UNITED STATES
NUCLEAR REGULATORY COMMISSION
WASHINGTON, D. C. 20555

MEMORANDUM FOR: Robert E. Jackson, Chief
Geosciences Branch, DE

SUBJECT: SAN ONOFRE 2 & 3 NUCLEAR PLANT SITE

<p>SAN ONOFRE NUCLEAR GENERATING STATION Units 2 & 3</p>
<p>LINEAMENT INTERPRETATION</p>
<p>Figure 361.27-2</p>

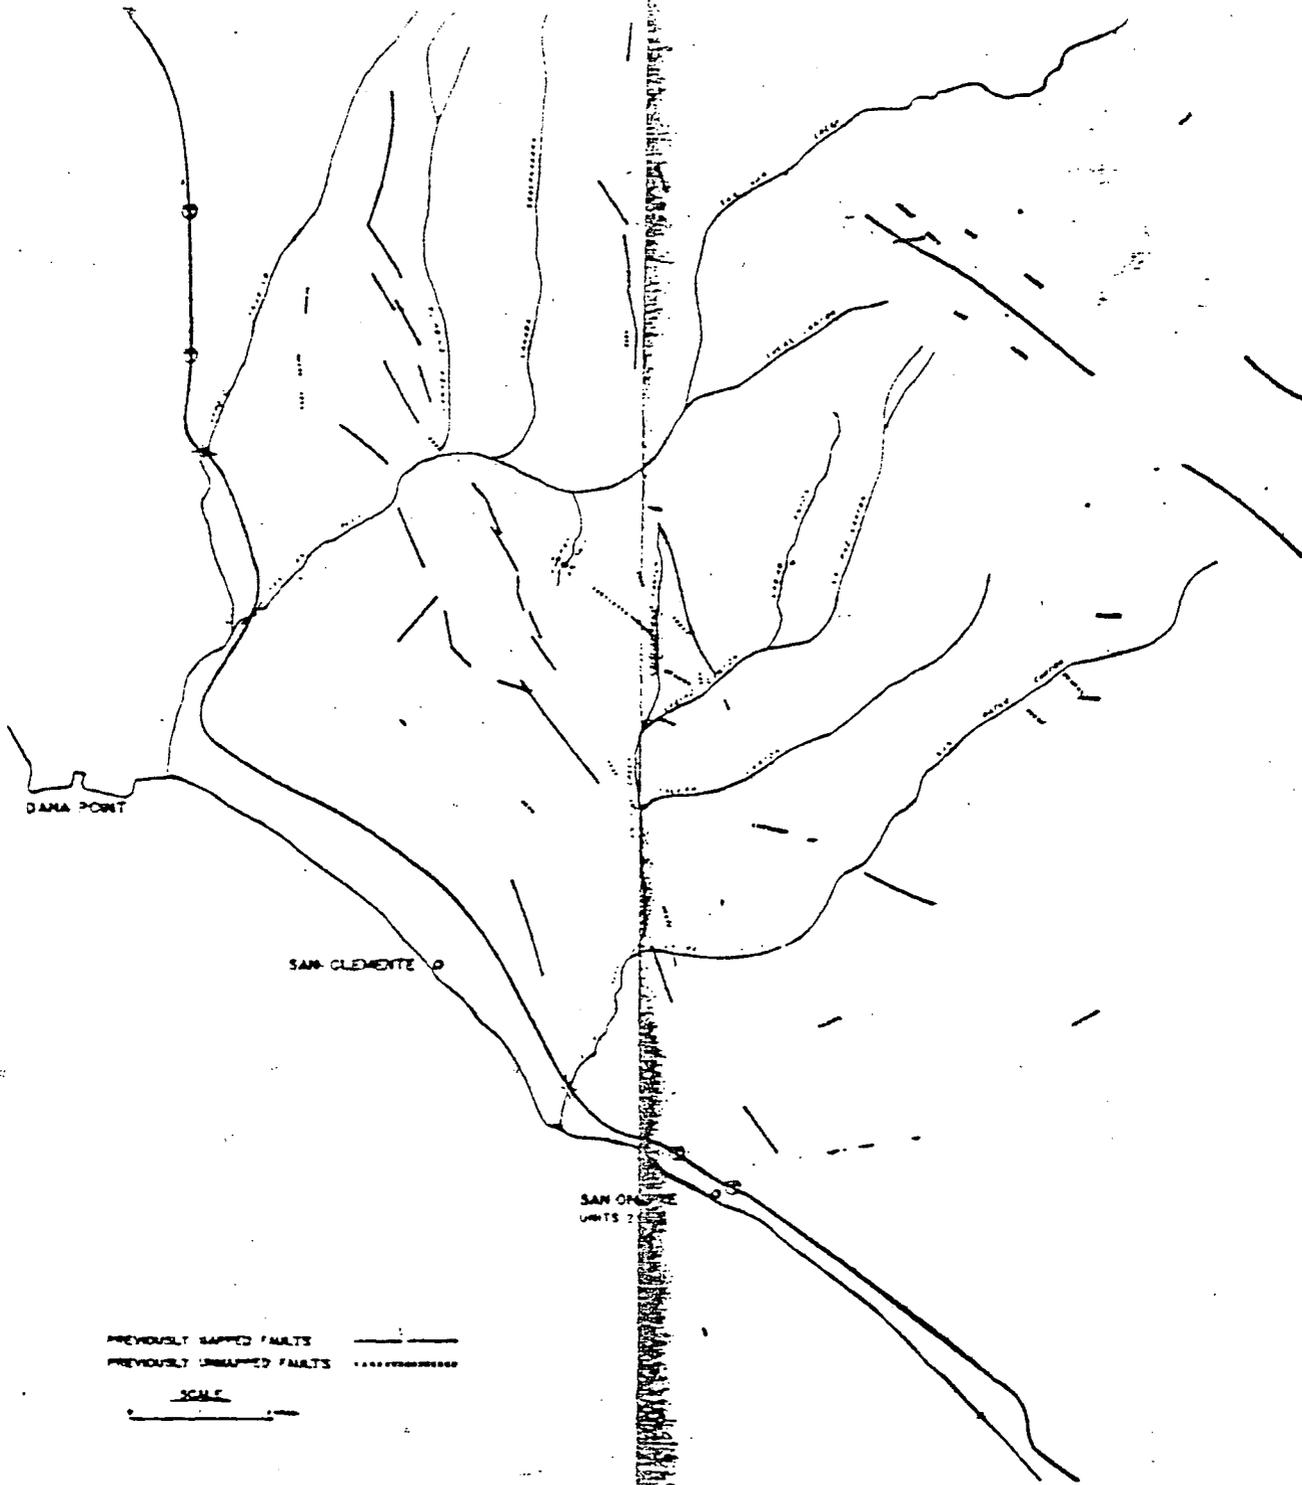
4 WITNESS CARDONE: This is the general area that
5 was looked at by the Applicant, where a lineament study was
6 made, and the area that -- of interest to us, here is the
7 San Onofre site.

8 WITNESS CARDONE: And the lineaments that
9 appear here were checked to determine their origin, and it
10 was found that on figure 361.27-1, that pretty much the
11 Cristianitos remains, the Cristianitos fault remains as the
12 structure observed in the lineament, the -- lineaments.

13 So, the point being, after all this, that there
14 is no indication of any lineations which could trend along
15 either the San Onofre Mountain fault or the Horno Summit
16 fault, which is an indication of either -- well,
17 discontinuous faulting, no prominent faulting, and/or old
18 faulting.
